**LEBANON PLANNING BOARD
APRIL 11, 2022 - 6:30 PM
COUNCIL CHAMBERS, CITY HALL OR
REMOTE VIA VIRTUAL PLATFORM
LEBANONNH.GOV/LIVE**

April 11, 2022 Meeting

Staff Memorandum – PB2022-10-SPR/PB2022-02-CUP – *con't from 2/22/22*

Subject: **Site Plan Review Application – Oakes Storage, LLC**
 92 Riverside Drive (Map 111 – Lot 16); Lebanon, New Hampshire
 KNA Project No. 21-1216-2

OA-1

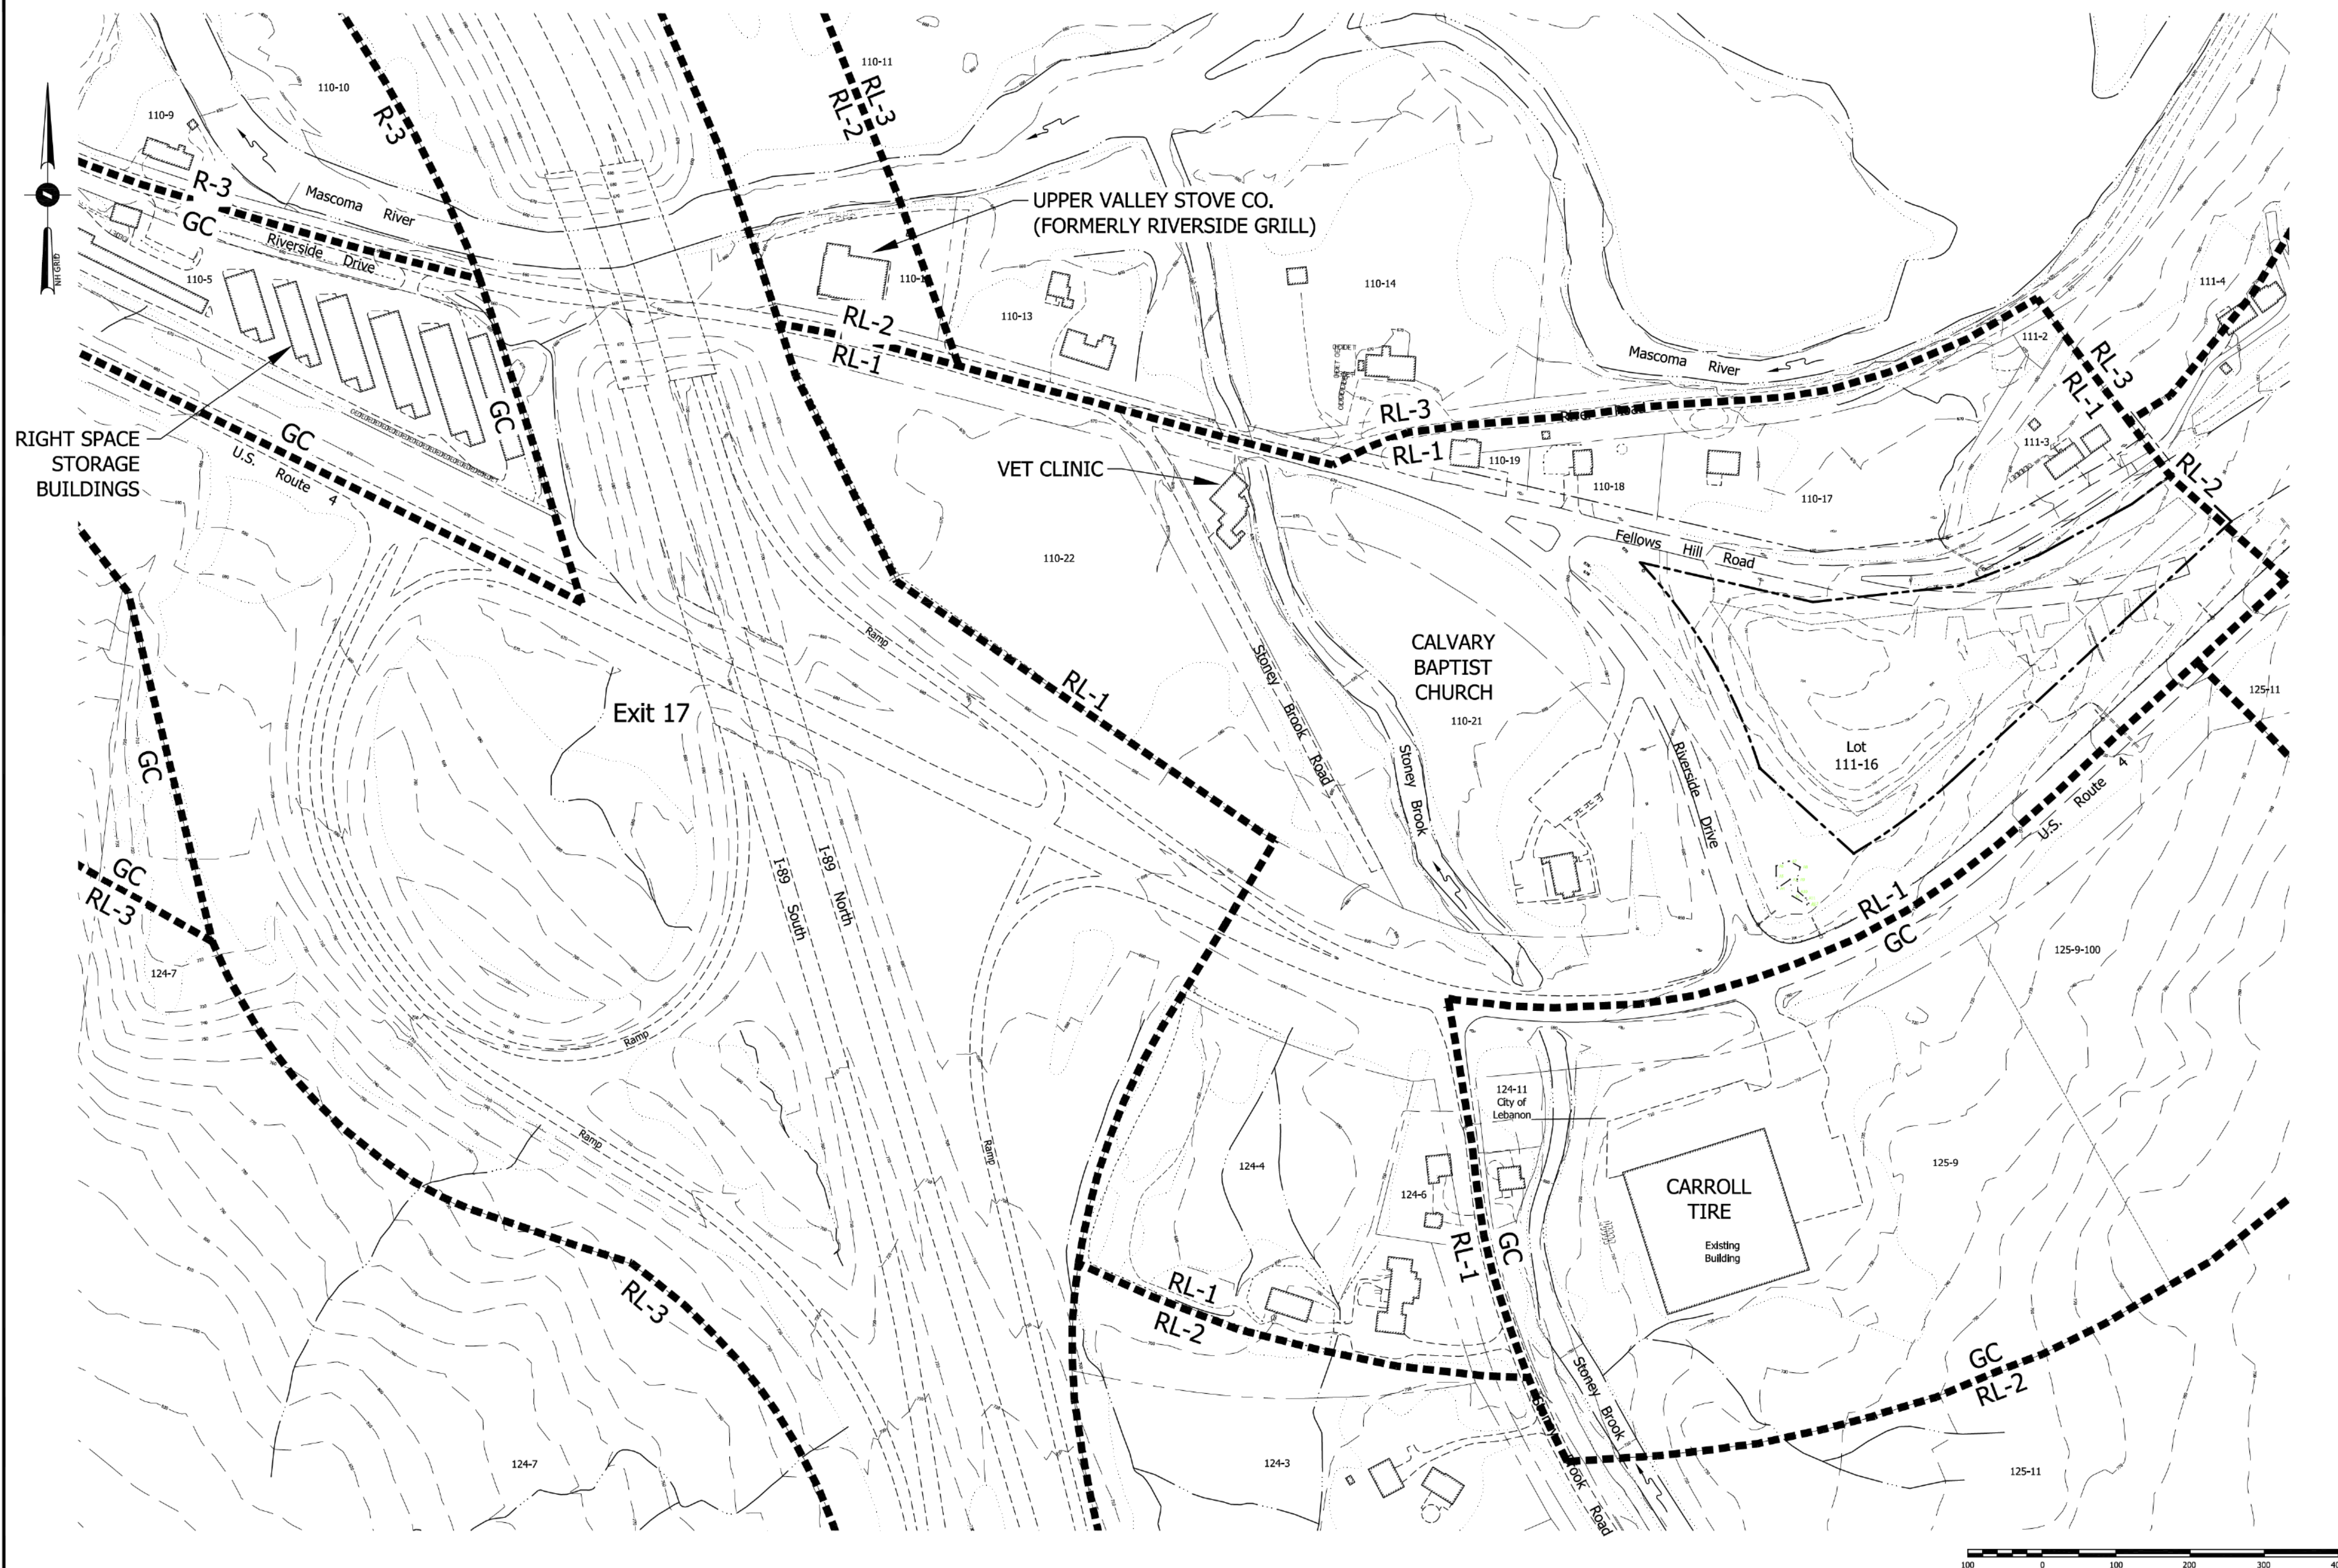
3. Note No. 6 provided on Sheet C-1 identifies a planned "entry control gate". We recommend the site plan specify the type and variety of proposed gate installation, including accommodations for 24-hour access acceptable to the Fire Department, prior to or as a condition of site plan approval.

L-1

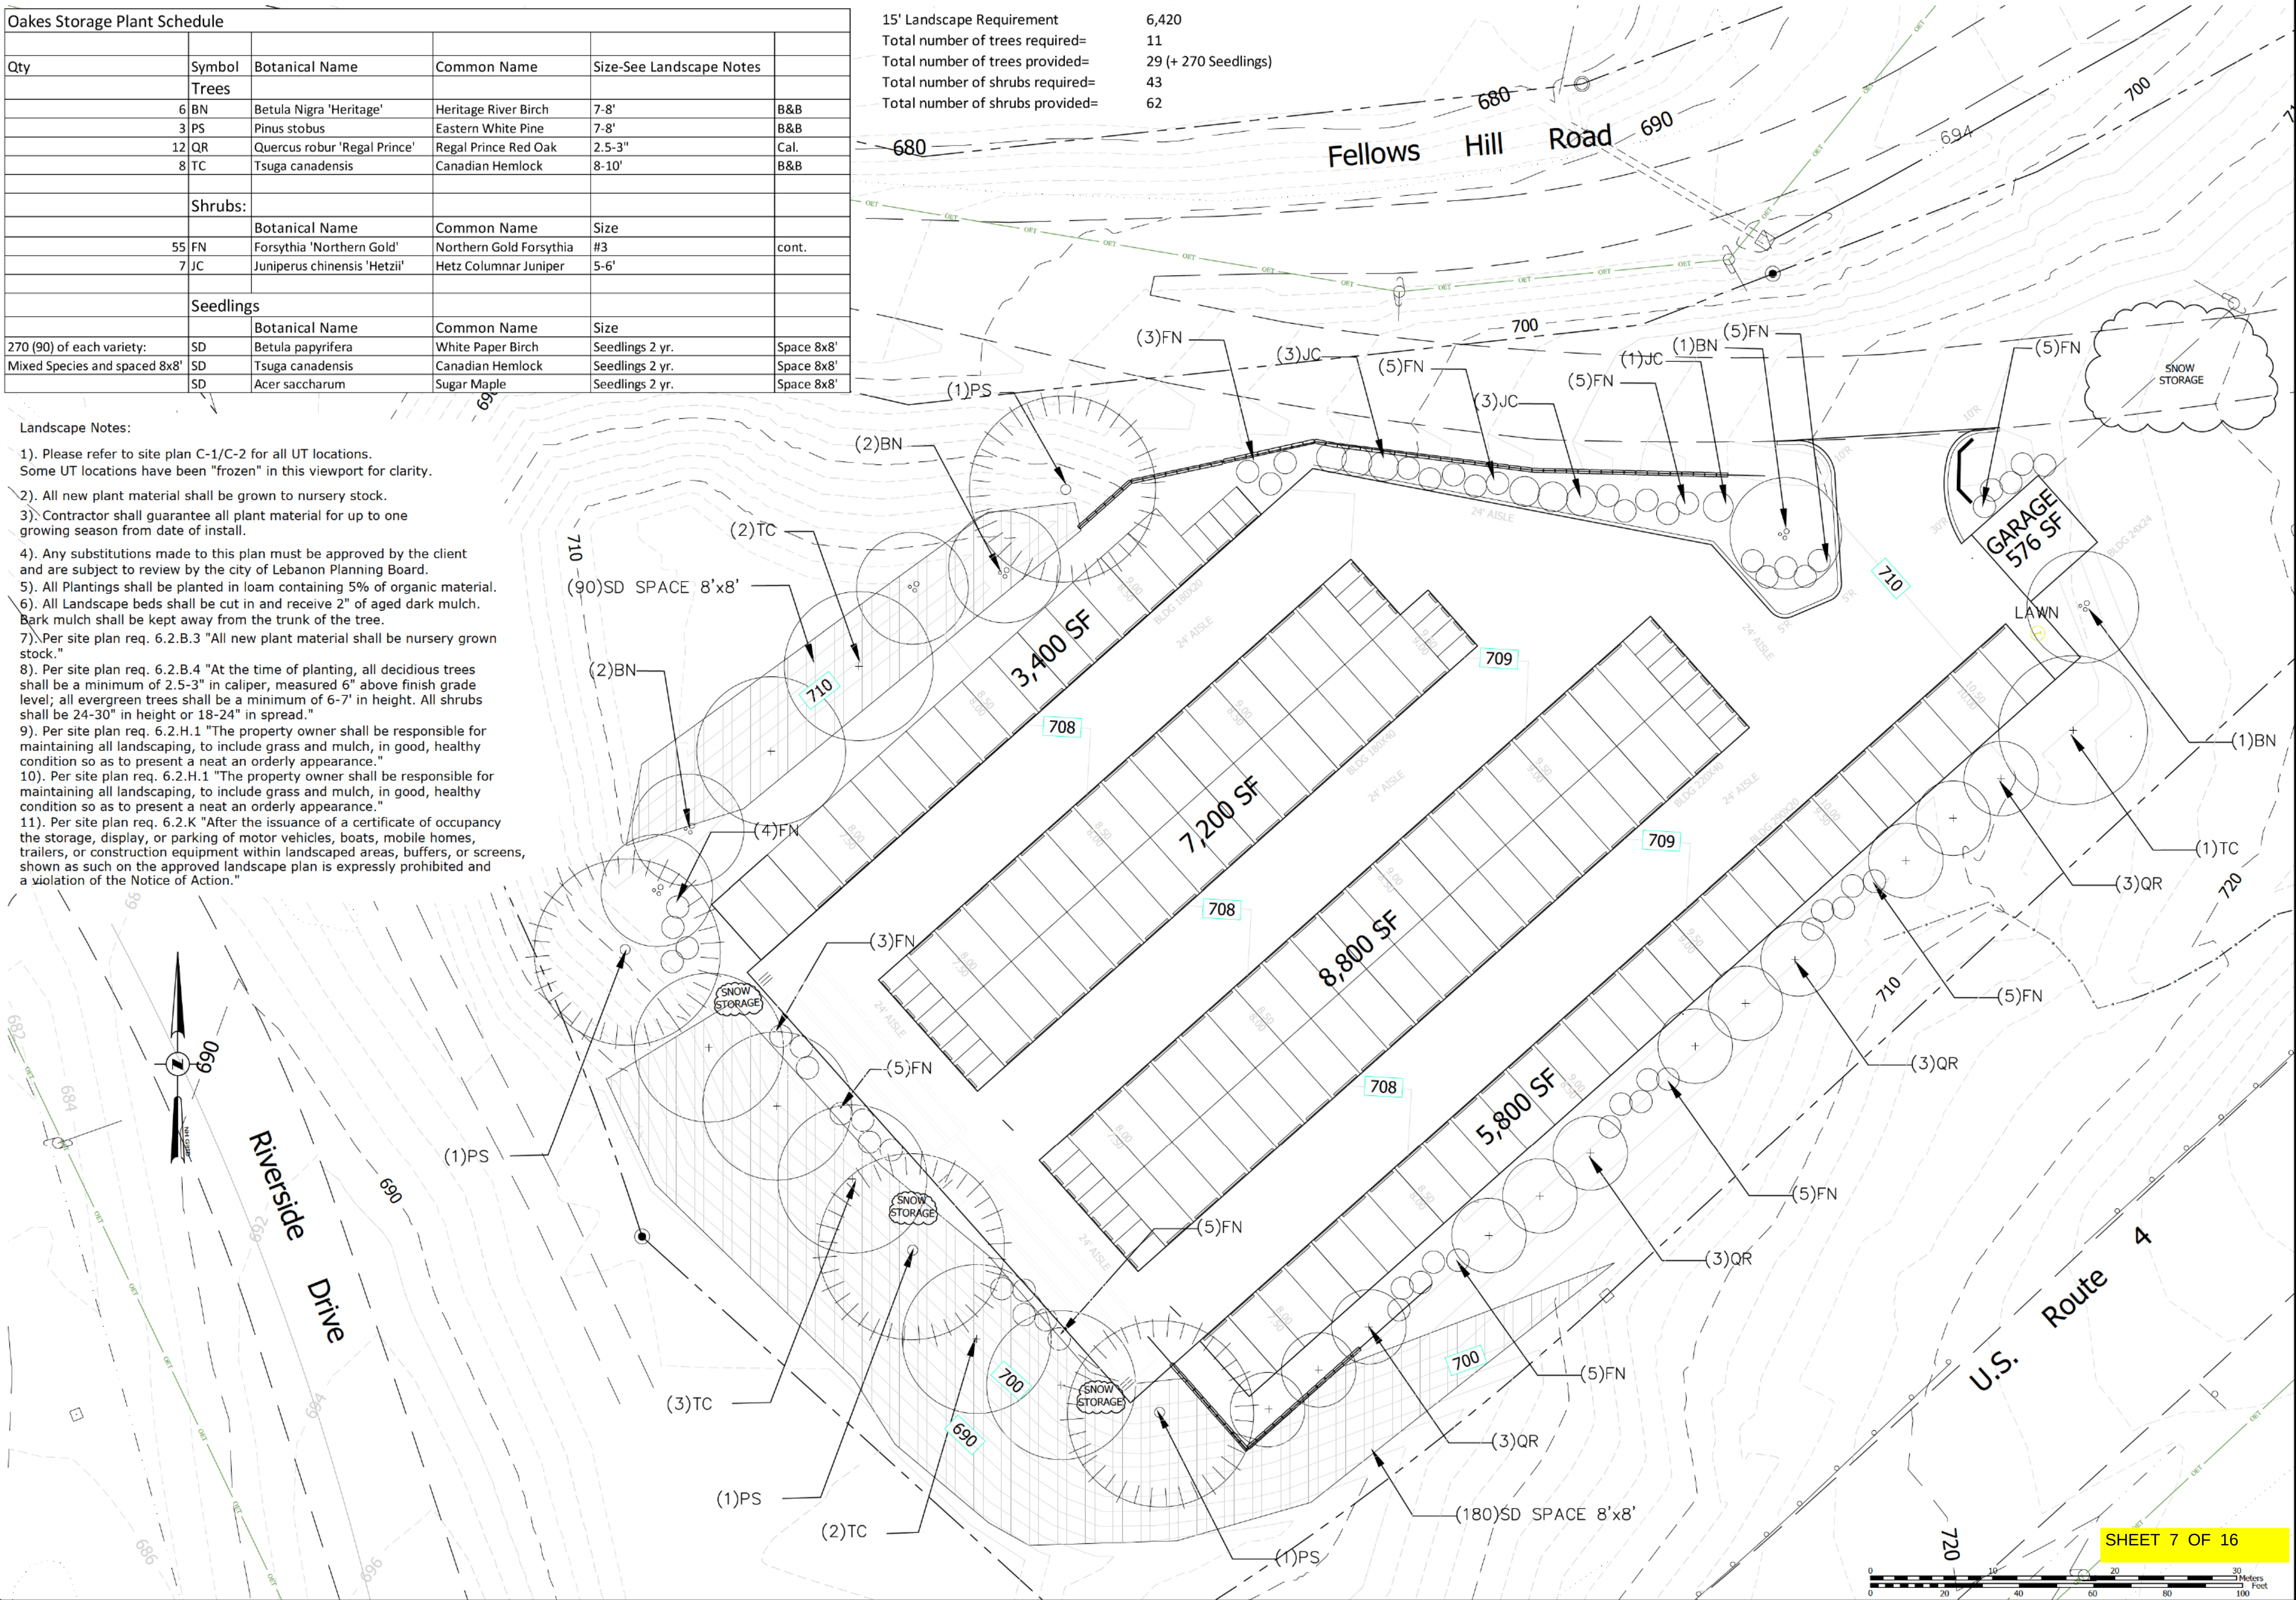
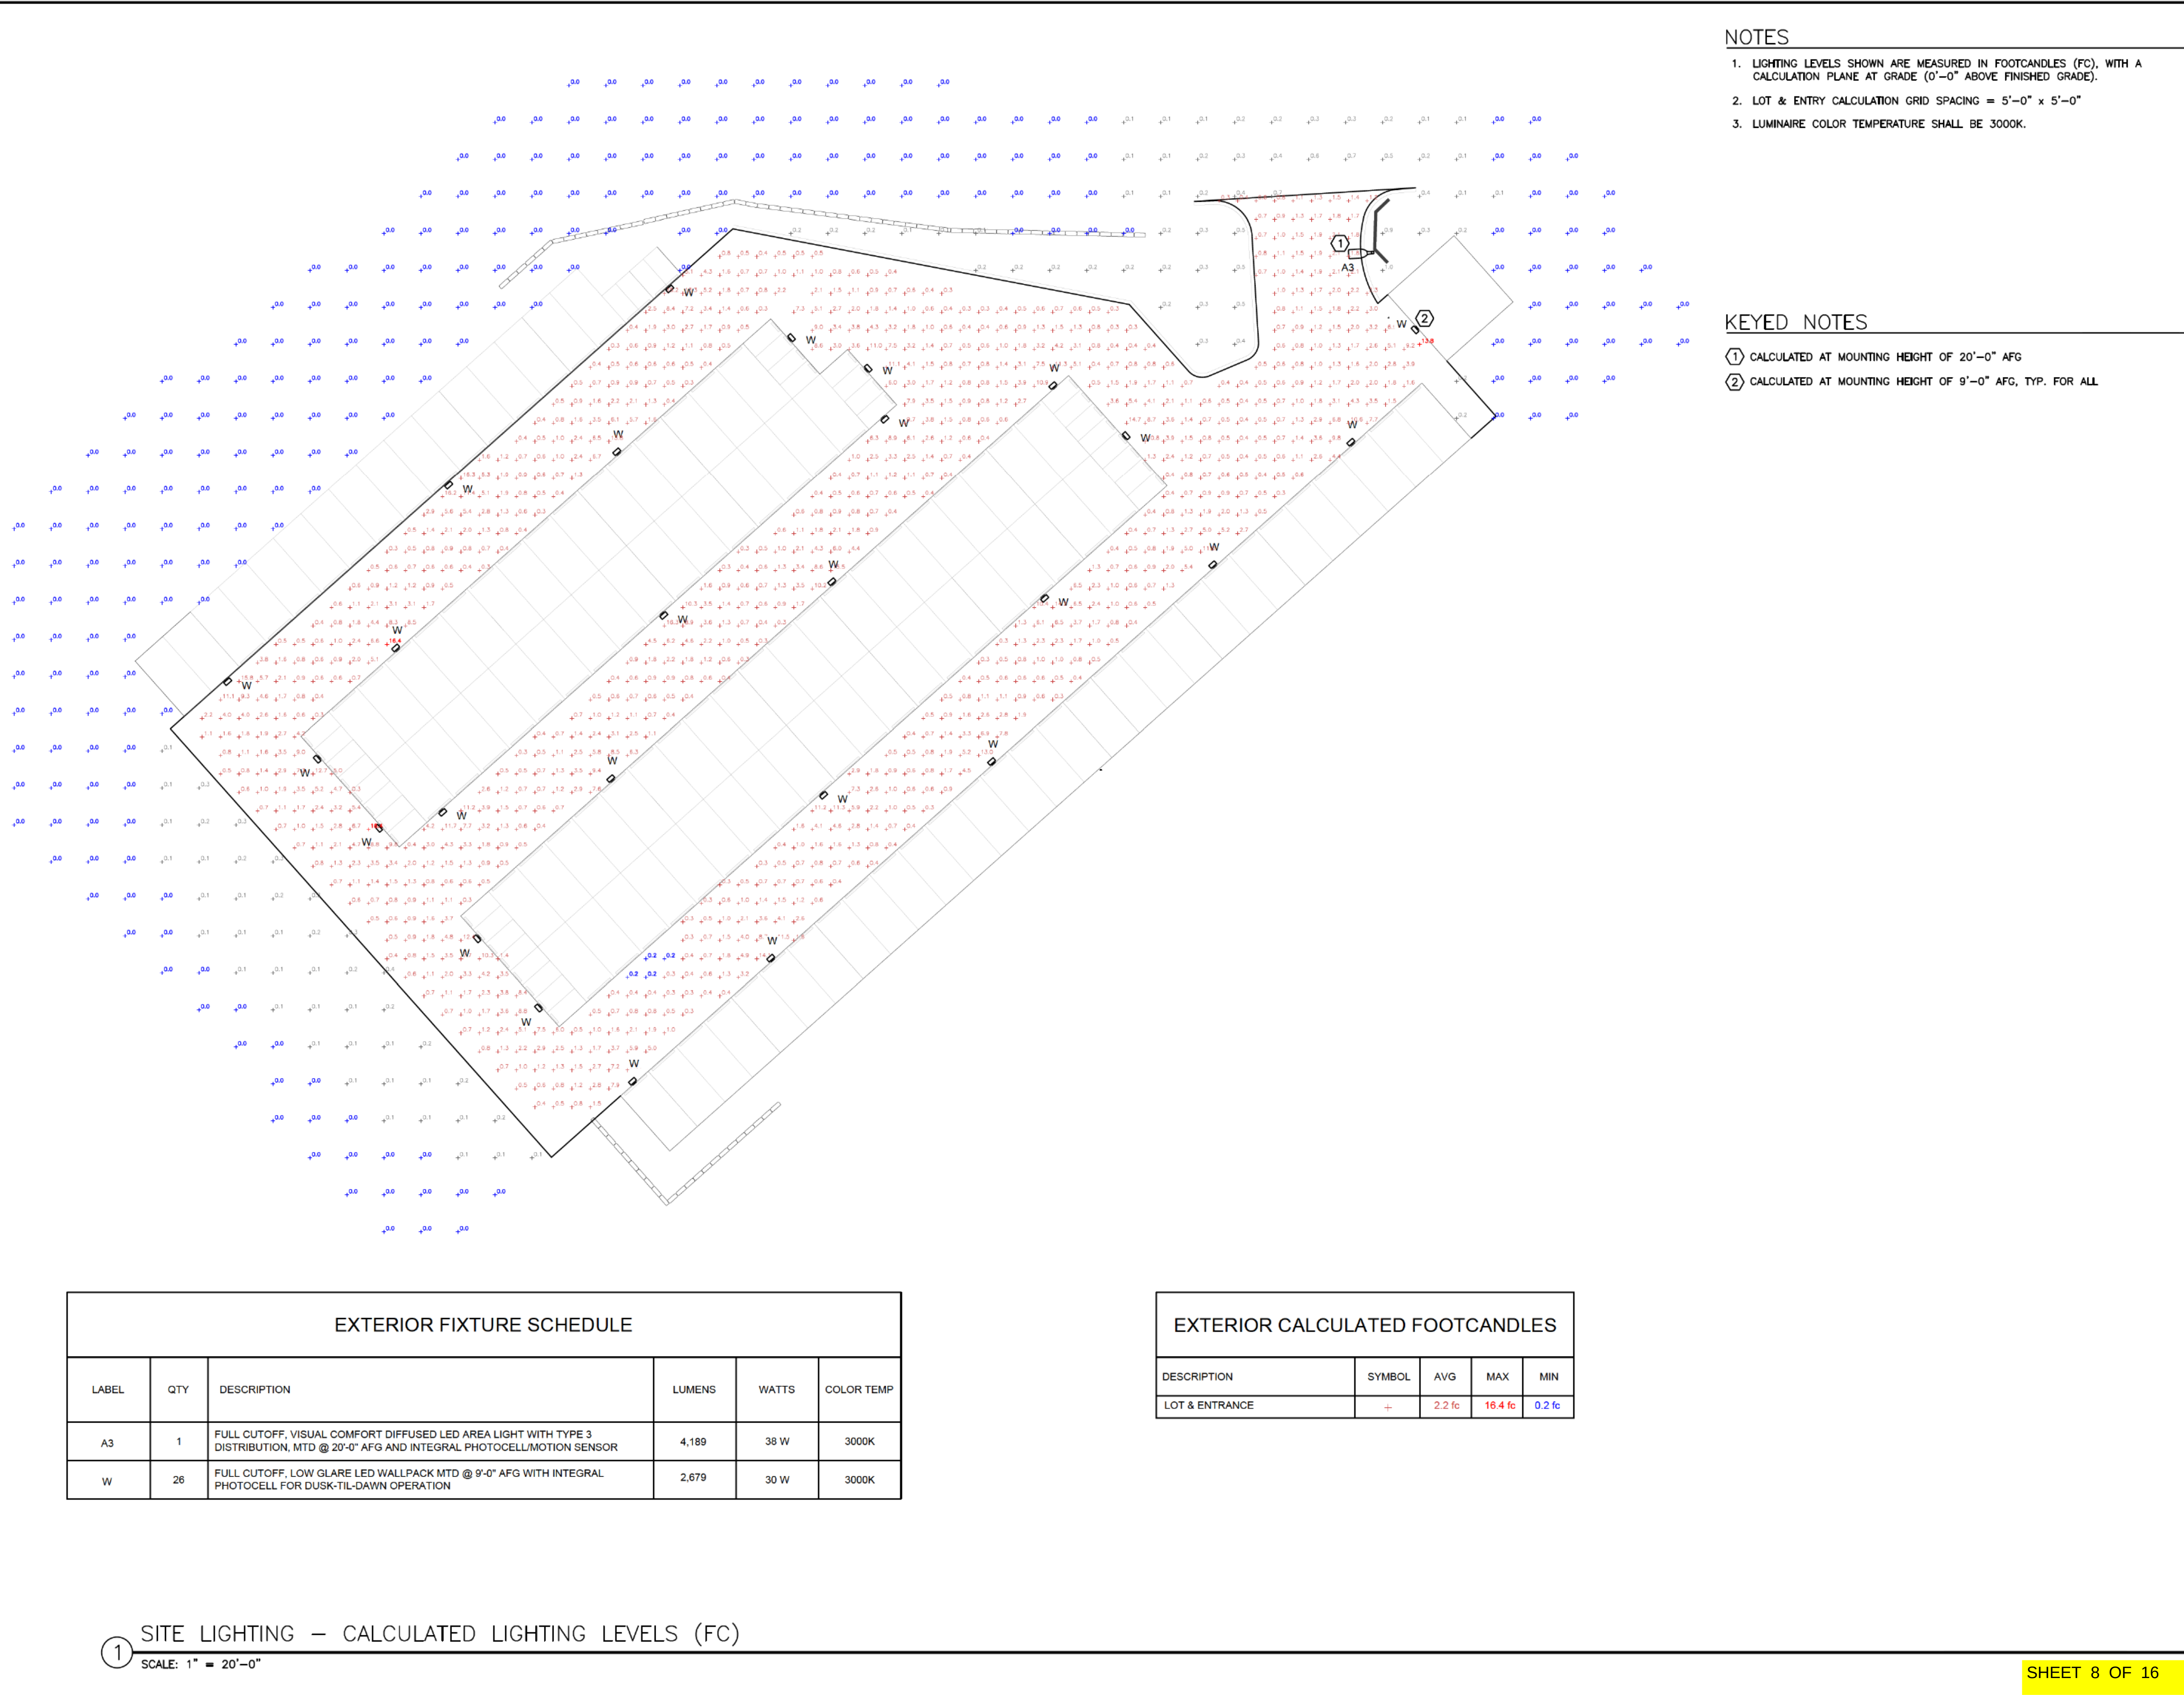
1. Based upon our consideration and review of Sheet L-1 (Landscape Plan) we continue to offer the following remarks:
 - In order to satisfy the requirements of Section 5.1.E.16 of the SPRR's we continue to recommend the drawing be expanded to provide required shading calculations.

- Landscape Notes No. 9 & 10 on Sheet L-1 are duplicative. We recommend Note No. 10 be deleted.
2. We understand detailed structural design drawings of proposed retaining wall construction will be submitted to the Building Department for review and possible approval at a future date. We recommend Building Department approval of proposed retaining wall construction, including detail of safety rail installation, be a condition of site plan approval.
